Access Compliance Report Public Rights-of-Way (Pedestrian Signals)

Main Street: **NEWLAND_ST** Cross Street: **HAZARD_AVE** Location: **SW**

ADA ID: **SGRK210929113741** Signal Type: **One Push Button-Non APS** Overall Compliance: **No** Severity Scores: **BTN 1: 35** **BTN 2: N/A** **No BTN: N/A**

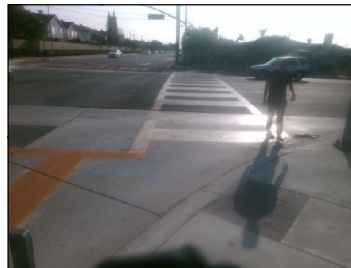
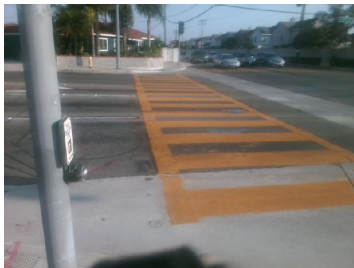
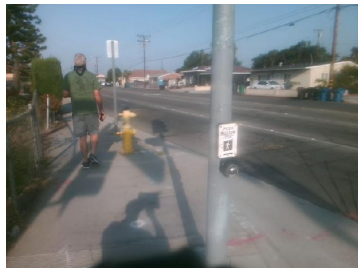
Possible Solutions: Replace Signal Push Button With APS Button. Remove and Replace Clear Space.

OC Std/PROW: R404.2, R404.3, MUTCD 4e.08
